Index 102-604 Two-Lane, Two-Way, Work in intersection

COMMENTARY

COMMENTS AND RESPONSES

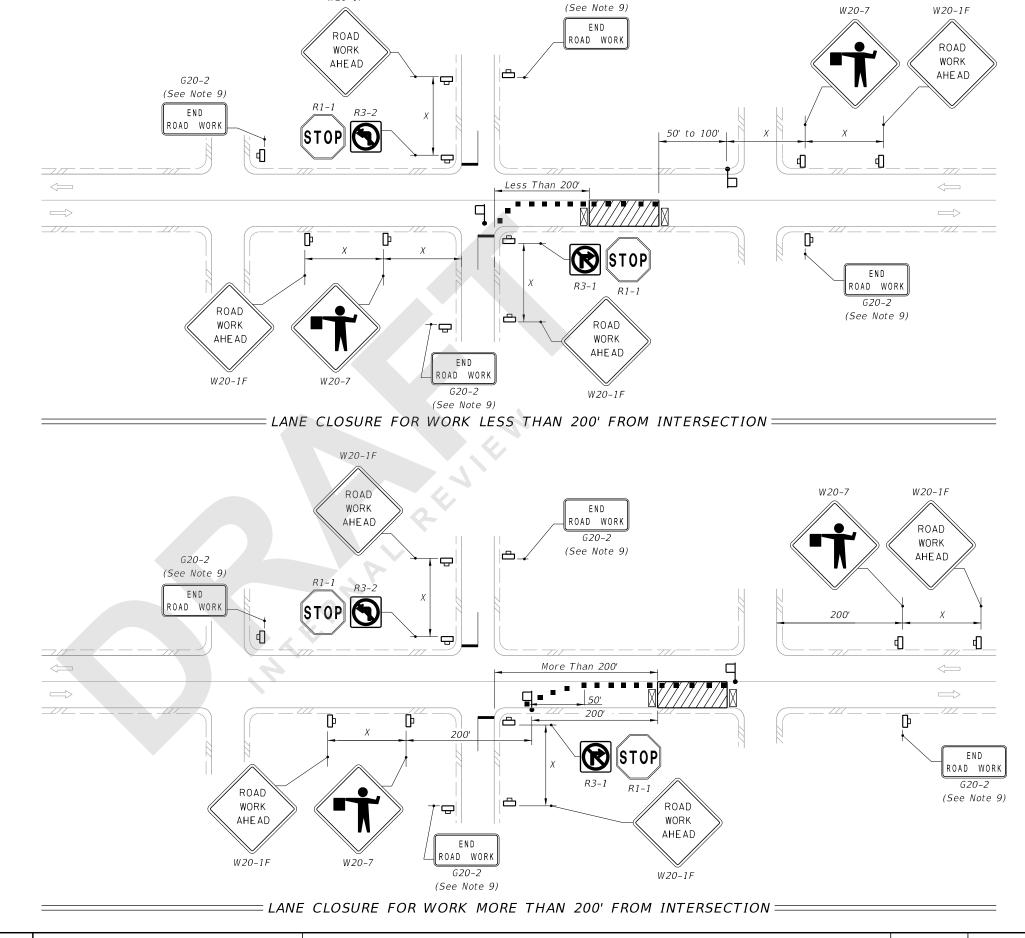
3. Second detail on sheet 1 is almost direct copy of first. Not sure why both are needed.

RESPONSE: Agreed; however, instead of removing, the second detail will be revised to clarify the differences.

Change Made: For the "...More Than 200' From Intersection" Detail, the distance between intersections will be expanded to better show that the flagger my not be located directly at the intersection and correct the sign spacings.
